Access Compliance Report Public Rights-of-Way (Curb Ramps)

Main Street: BENJAMIN_DR Cross Street: ANTONIO_PKWY Location: NW

ADA ID: RPRK211028164919 Ramp Type: Type 1 - Perpendicular Diagonal Initial Pass/Fail: Fail Overall Compliance: No Severity Score: 16

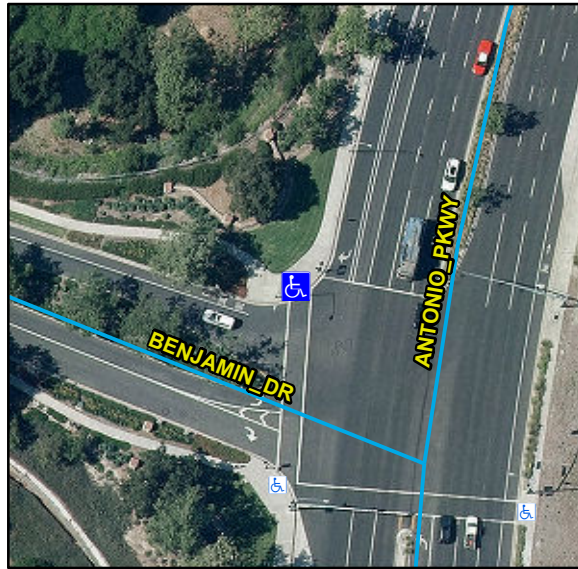
R304.2.2, R204.3, R304.5.3, STD 1115

Remove & Replace Curb Ramp With Two New Directional Ramps or Equivalent.
